**ROCKFORD BOARD OF EDUCATION
INVITATION FOR BID ON SUPPLIES, MATERIALS, EQUIPMENT OR SERVICES
FOR SCHOOL DISTRICT NO. 205
ROCKFORD, ILLINOIS**

IFB No. **23-27 Asbestos Abatement at Washington, Flinn & East Schools**

RE: **ADDENDUM NO. 1**

**SUBJECT: ADDENDUM NO. 1 TO THE BIDDING DOCUMENTS IFB NO. 23-27
ASBESTOS ABATEMENT AT EAST, FLINN, AND WASHINGTON SCHOOLS**

2 ASBESTOS ABATEMENT PLAN
1ST FLOOR

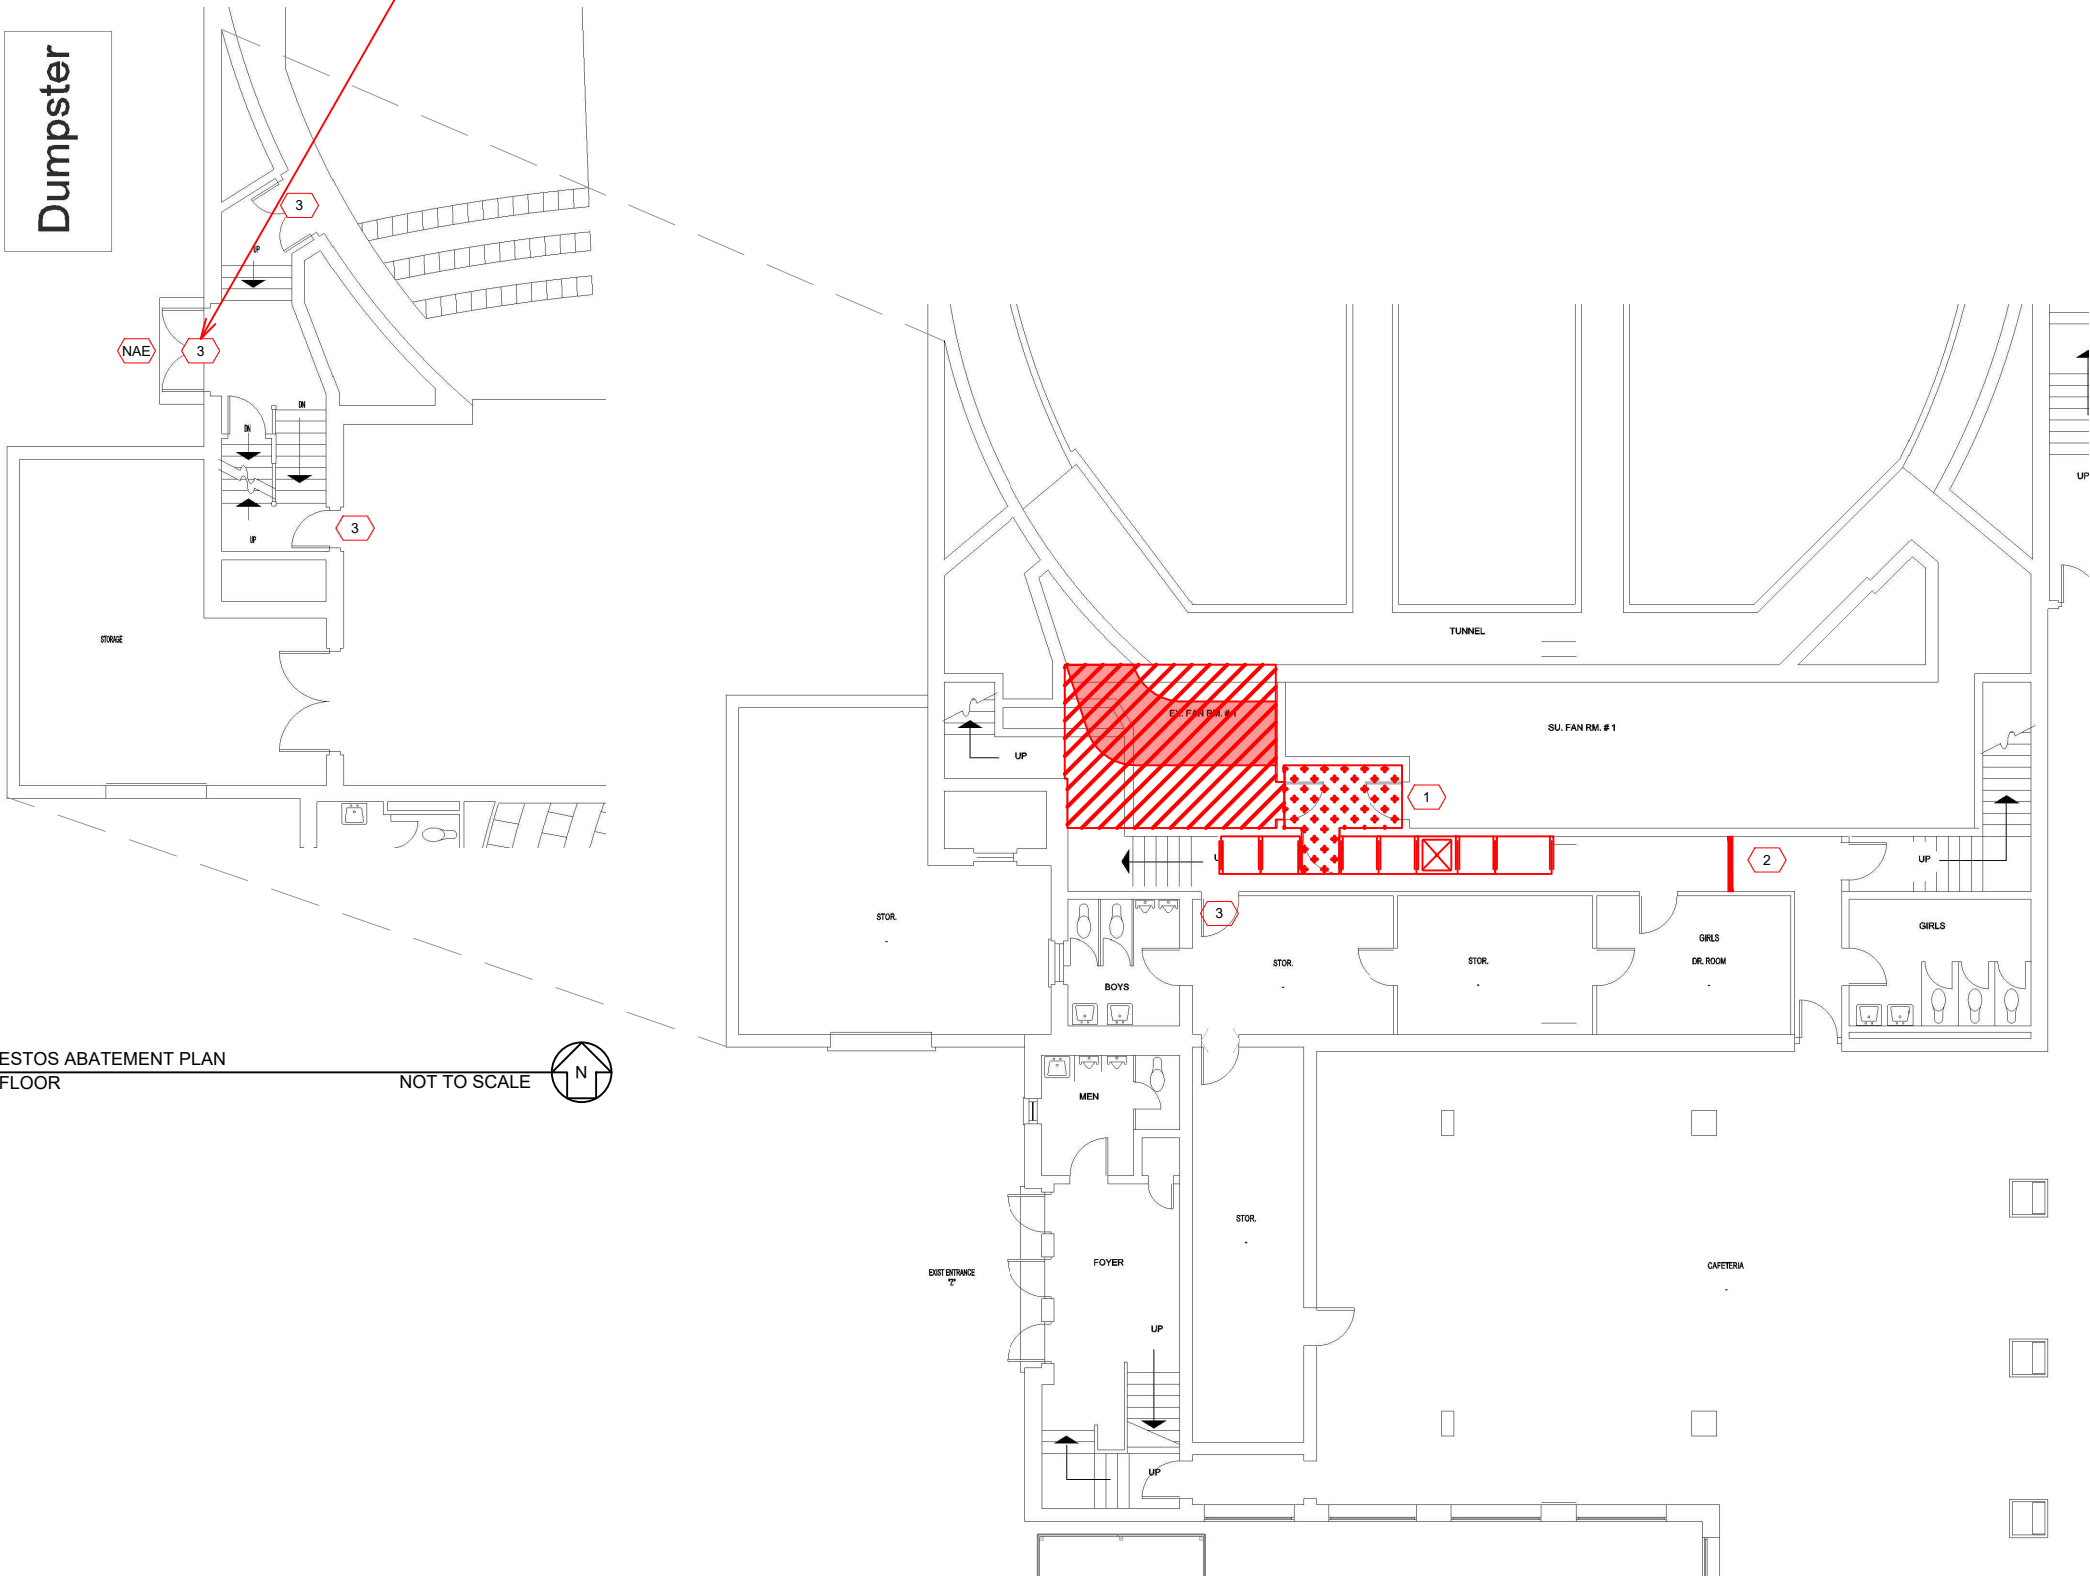
1. ASB-G: Scope of work, schedule, and bid allowances modified.
2. ASB-1: Scope of work modified.
3. New Bid Form

Worker decontamination unit.
	Waste decontamination unit.
	Negative Air Exhaust
	Separation barrier per IDPH 855.430(a)
	Separation barrier per IDPH 855.430(b) (with lockable door)
	Contractor to secure door and control access
	Asbestos Abatement Work Area
	Containment Tunnel - No Removal
	Abatement of ACM Duct Insulation and Demolition of Duct

1 ASBESTOS ABATEMENT FIRST FLOOR PLAN

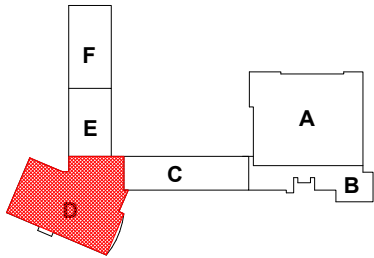
1. ASB-G: Scope of work and bid allowance modified.
2. ASB-1: Additional mini-containment in storage room. Removal of scope of work in tunnels and associated decontamination units/barriers. Additional scope added regarding the demolition of soffit in faculty lounge.
3. New Bid Form.

1. Mini-Enclosure Abatement of Pipe Insulation.
2. All work per Specification Section 02 131 applicable IDPH, IEPA and OSHA regulations.

1 ASBESTOS ABATEMENT
FIRST FLOOR PARTIAL PLAN

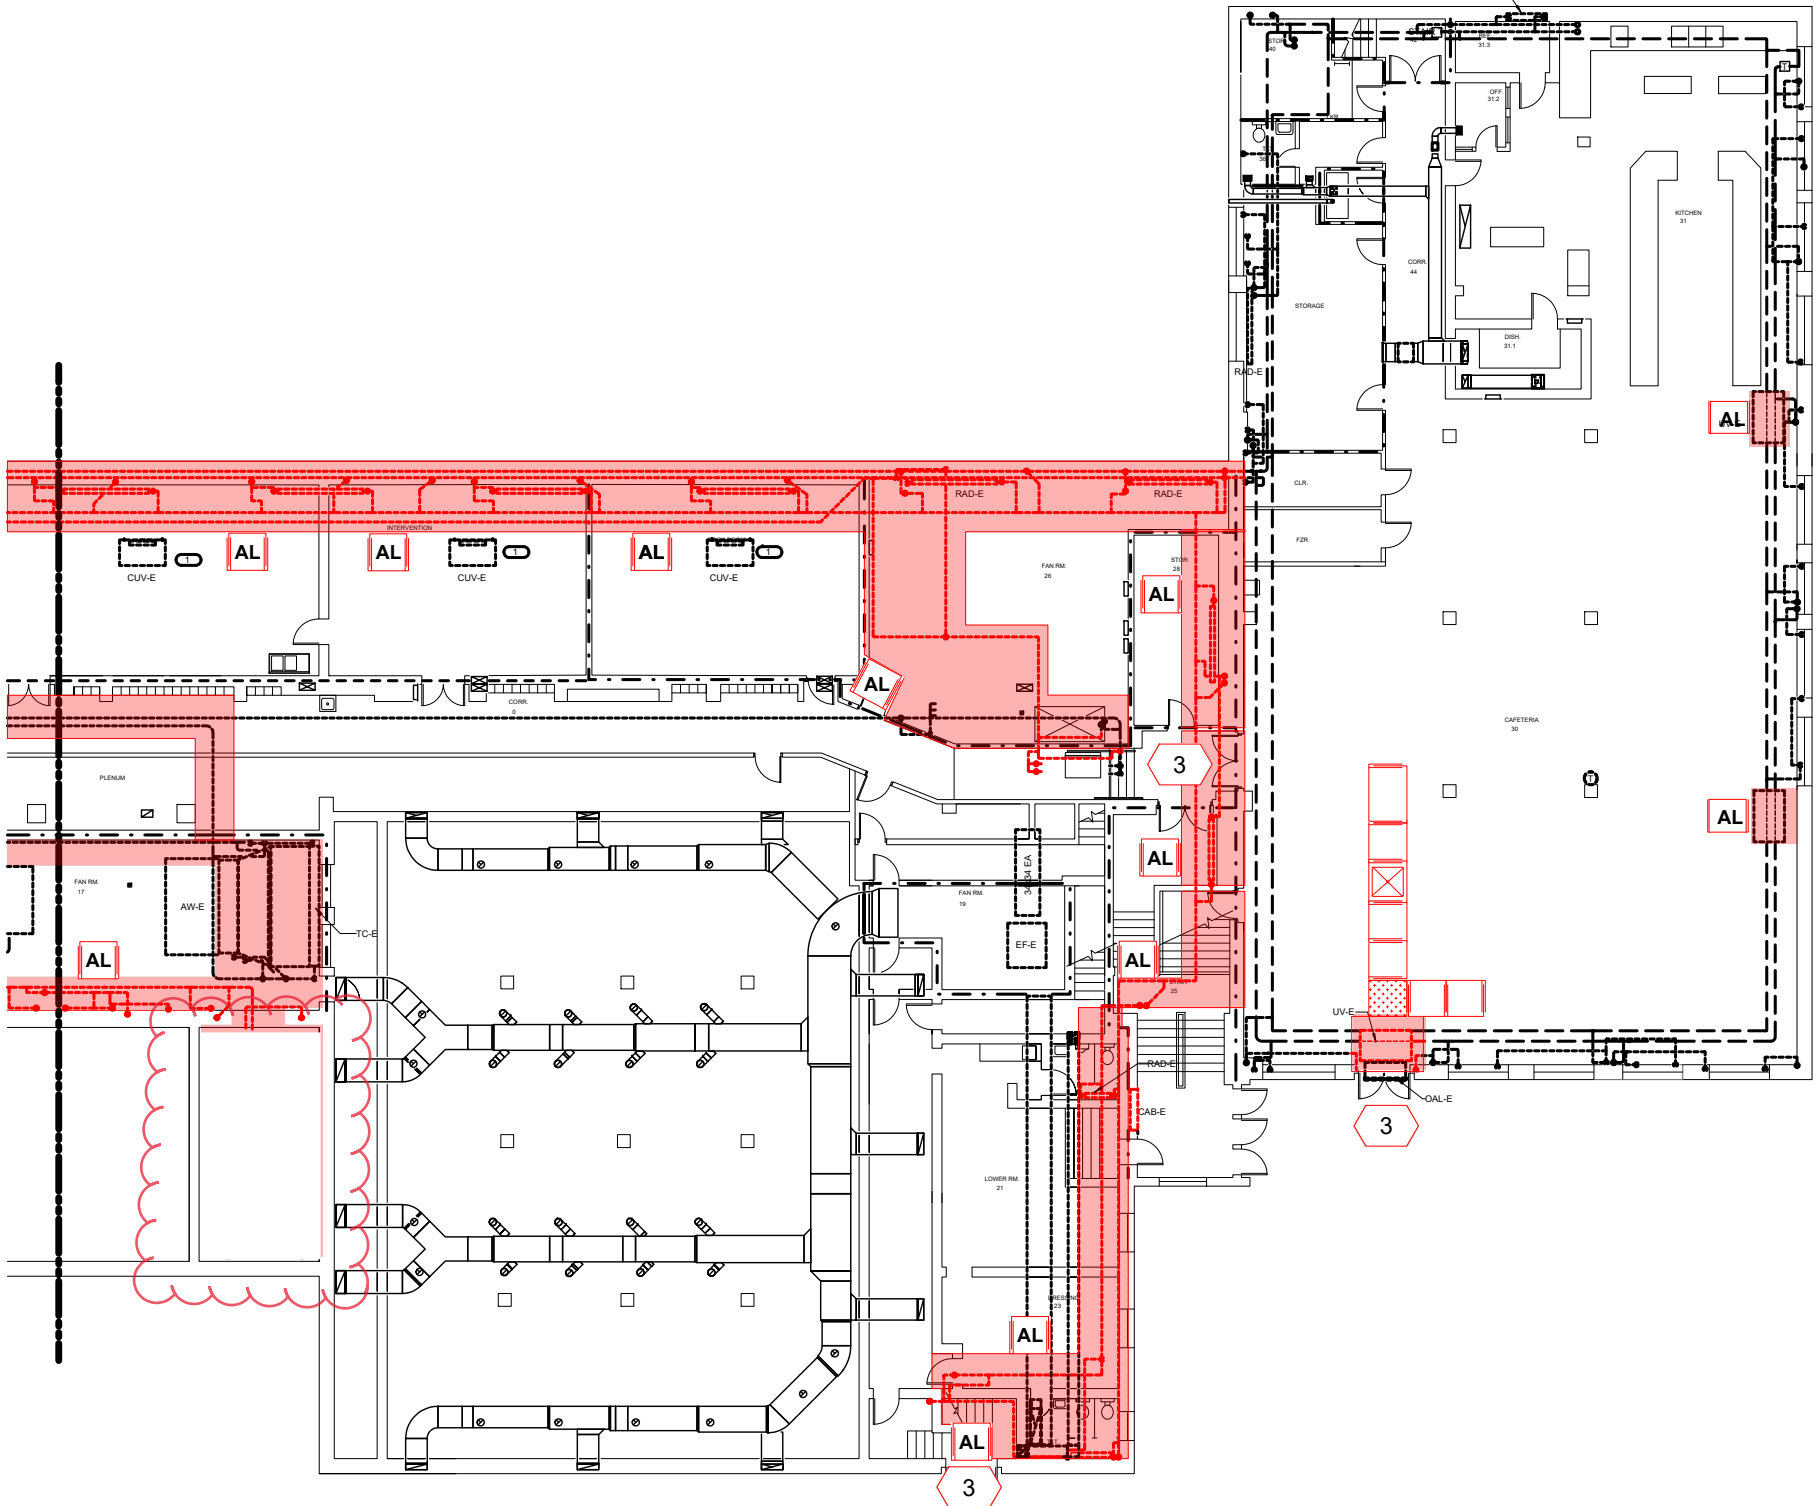
1. ASB-G: Change to schedule and bid allowance.
2. ASB-1: Title block modified.
3. ASB-2: Scope of work reduced.
4. ASB-3: Title block modified.

1. Mini-Enclosure and gross removal of pipe insulation.
2. Demolition of wood riser guards, ceilings, or walls as necessary to access piping scheduled for removal per AOR drawings.
3. All work per Specification Section 02131 applicable IDPH, IEPA and OSHA regulations.
